Ref: CLT/WHC/ENA/24/14702

ICOMOS Technical Review

Property	Gelati Monastery
State Party	Georgia
Property ID	710bis
Date inscription	1994
Criteria	(iv)
Project	Proposal on the Arrangement of the Temporary Roofing over the Church of the Virgin

Fig. 1. The drum with visible results of active moisture. The walled window openings on the west side of the tholobate.

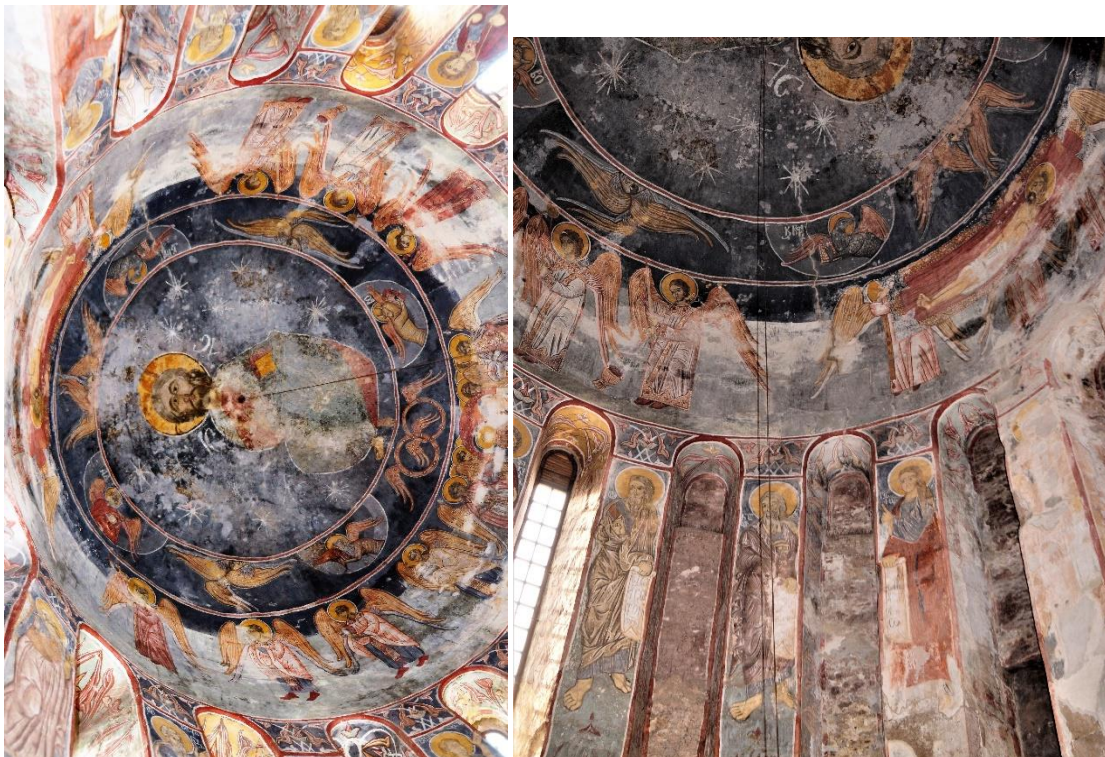
- ii. Visible effects of long-term water infiltration accompanied with salt crystallization and moisture action on the church cupola's interior building blocks and its wall-paintings are assessed at the tholobate level of the dome. Moisture on the pillars between the window openings on the west side of the tholobate has caused serious damage to the representations of prophets, as well as to the building blocks of the ring base of the drum. It should be noted that these window openings have been walled in the distant past, either for reasons of strengthening the bearing capacity of the extremely tall dome, or to block the inflow of rainwater, or for both reasons. In fact, due to this fact, the only internal exit to the outside of the cathedral has also been blocked. In the western dome area, the effects of moisture (recent and older) are evident and are in fact within the masonry areas that have been repeatedly repaired with the use of cement even in the recent past, long after the walling of the window openings (Figs. No. 1, 2, 3, 4).

Fig. 12. Schematic alternative proposal for supporting the vertical bearing tower with full covering of the cupola.

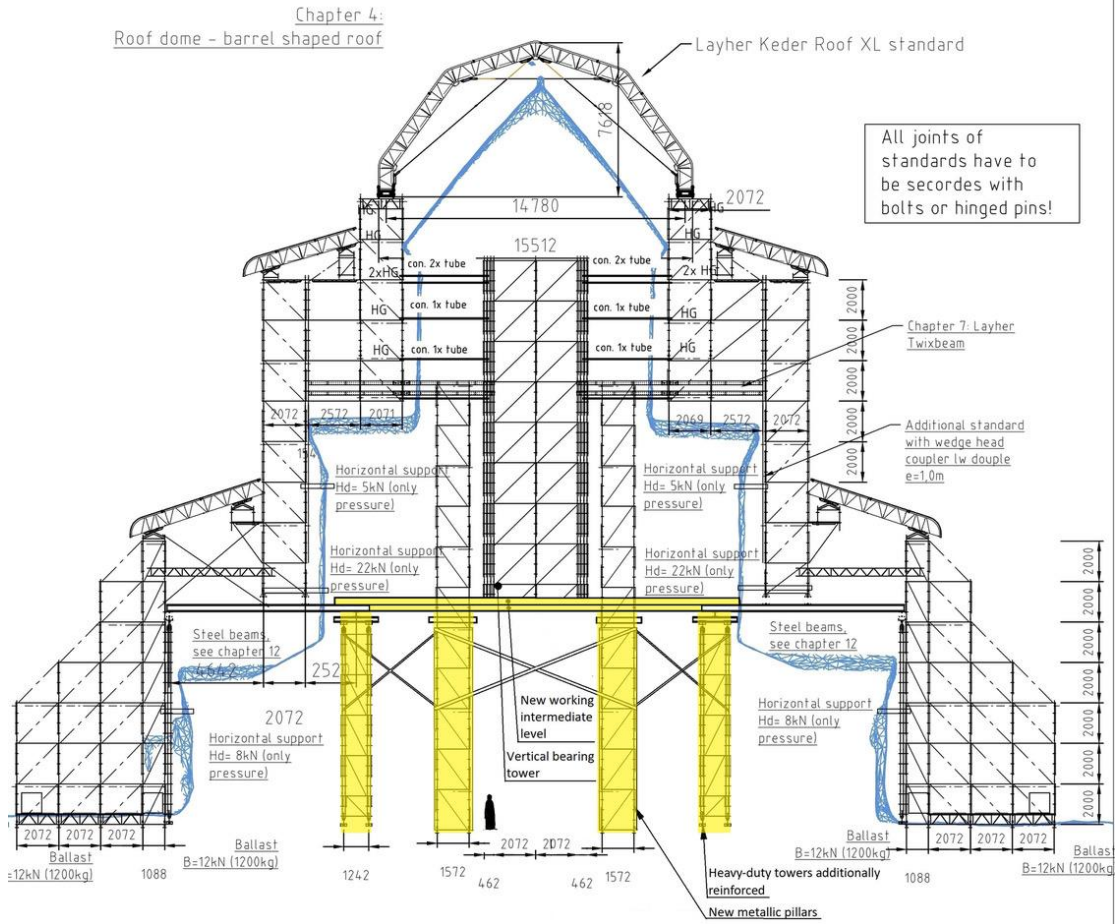
Considering that the dome will be completely covered, and in view of the requirement of a central pillar (vertical bearing tower) in order to stabilize the dome structure against horizontal loads such as wind and earthquakes, it is not inevitable that this structure should reach to and rest on the ground level of the cathedral. The central pillar can rest at an intermediate horizontal plane, constructed at a suitable height from the ground level of the cathedral, with sufficient strength to receive the loads from the overlying structure. Judging from the provided scaffolding structure cross section plan (Annex 3, p.2), the intermediate plane could be constructed at the height of the foreseen first horizontal support (ca. 10,10 m.). Ultimately, this intermediate plane could be supported on the ground level by 4 metallic pillars at the four eagle points of the inscribed square inside the projection of the dome base circle, being cross connected to each other at a reasonable height. Alternatively, the working intermediate level could rely on the predicted heavy-duty towers beside the centre of the cathedral – those being additionally reinforced - or on a combination of both supporting systems (pillars and towers). Thus, this alternative solution will free up sufficient space in the central part of the cathedral (ca. 6,80 m. between the 4 metallic pillars), so that the performance of liturgical services would not be restricted, neither would the free access of pilgrims and visitors be hindered throughout the time frame of the restoration work.

An explanatory-schematic construction plan is attached, based on the modification of the proposed construction plans by the State Party (Fig. 12).

Fig. 13. Ancient drainage channels found around the churches of the Monastery.

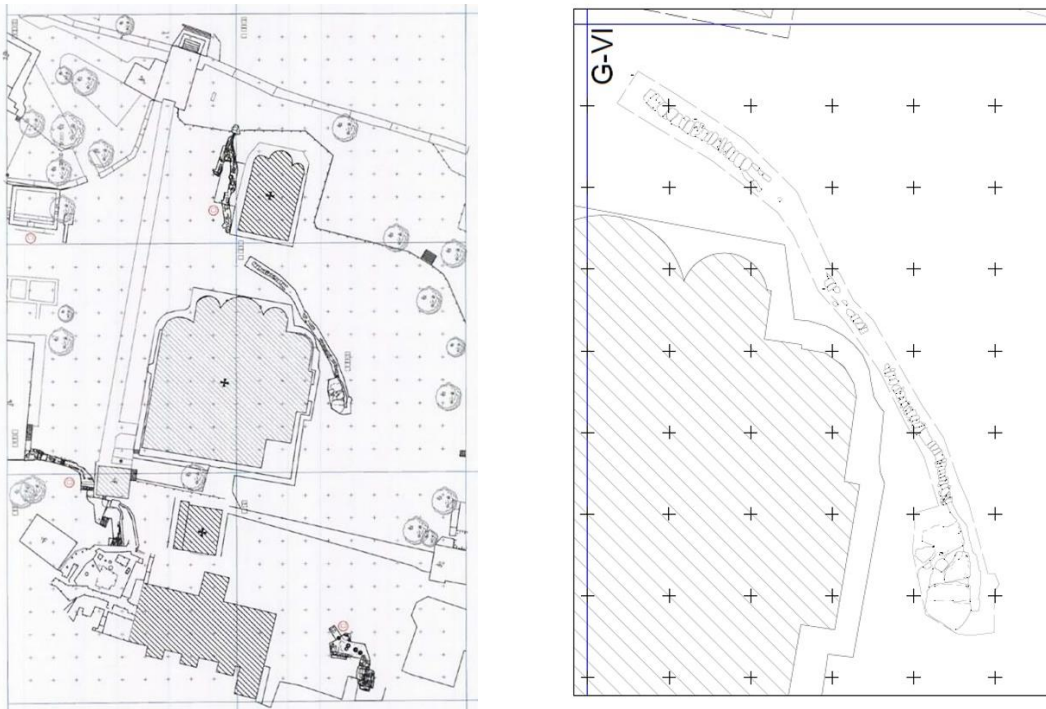
On this matter ICOMOS notes that during archaeological excavations, ancient drainage channels have been found around the churches of the Monastery. The ancient water drainage system is out of order for a long time and, moreover, it is not visible as it is covered by the ground (cf. Photo Report on Drainage Collector restoration-rehabilitation (2018-2019) shared by Georgian Expert Team; Annex 2_State of conservation report Gelati Monastery, 2020, p. 234, Drawing N4 – see here attached: figs. 13, 14, 15, 16).

The ancient system is placed differently from the recent system (2019-2020) for the collection and passage of water, consisting of downpipes, sewer manholes and a sewage network outward from the Church of the Virgin. Consequently, particular attention should be paid to the substructures of the South East main pillar and of the external southern secondary pillar of the proposed design for the scaffolding structure.
